**ADDENDUM NO. 1**  
**TO THE**  
**DRAWINGS AND SPECIFICATIONS**  
**FOR THE**  
**Rockport Road Sidewalk**

**Issue Date:** November 8<sup>th</sup>, 2017

CITY OF BLOOMINGTON  
ROCKPORT ROAD SIDEWALK

GRADING AND DRAINAGE PLAN

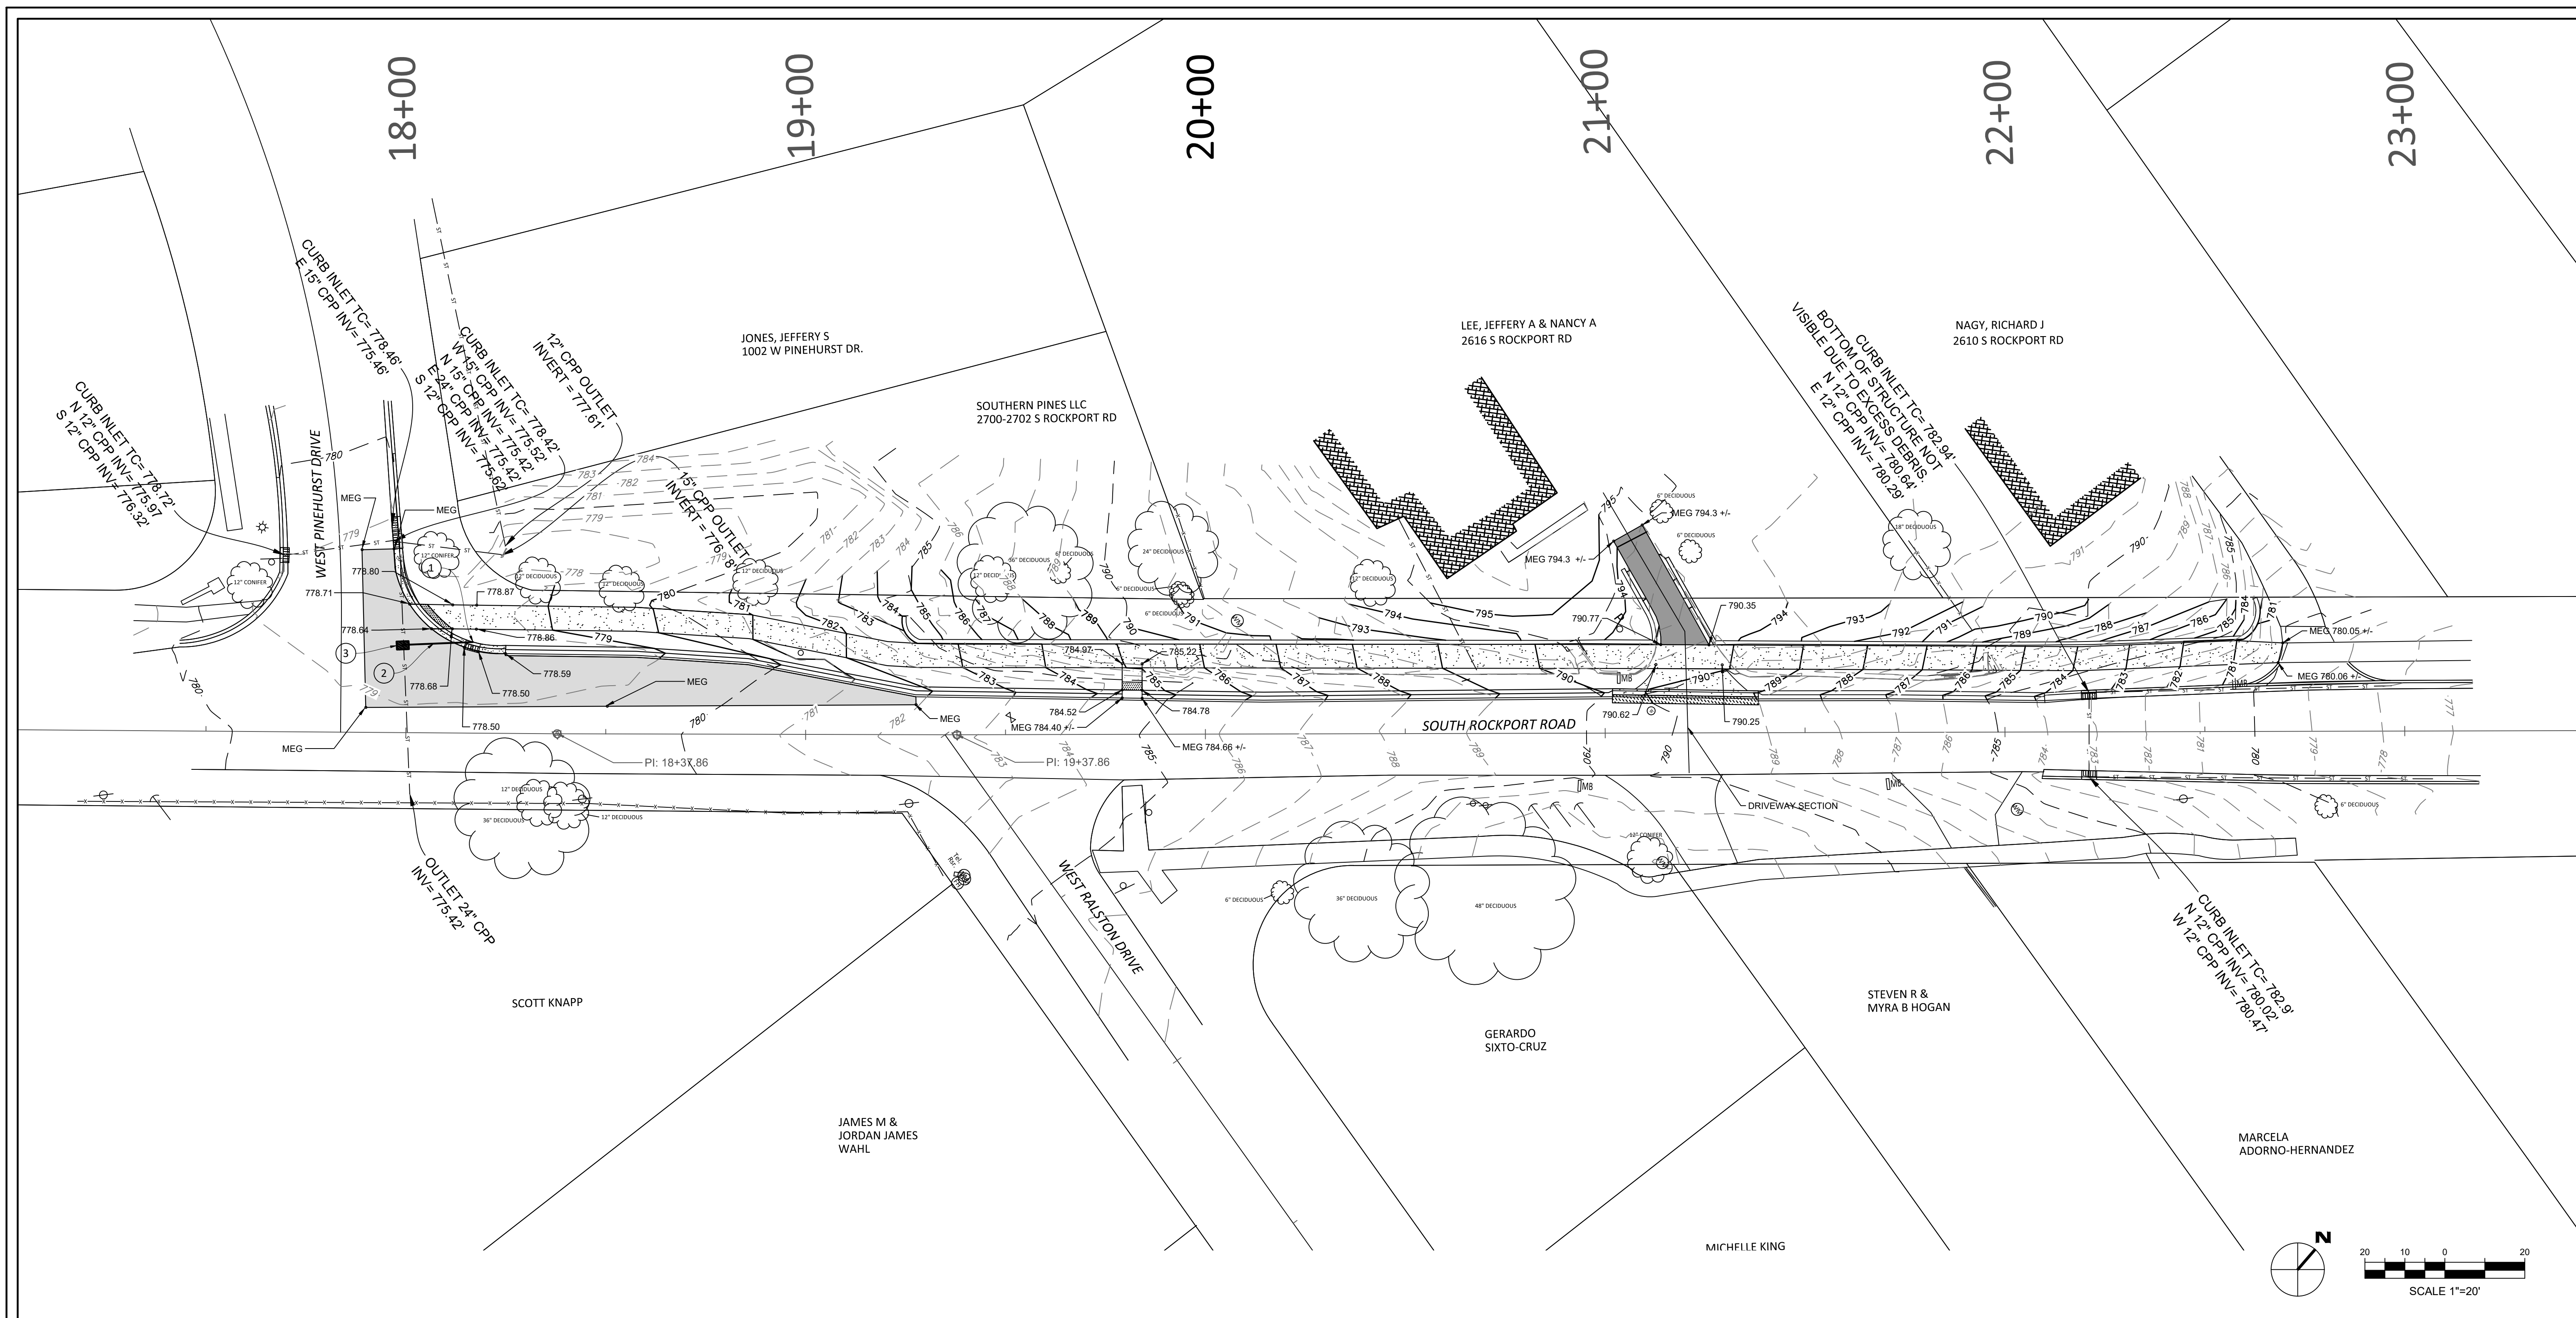
**Item No. 1:** A revised 'GRADING AND DRAINAGE PLAN', Sheet C401, has been issued and is attached to this addendum. The project shall be built as shown on the revised sheet.
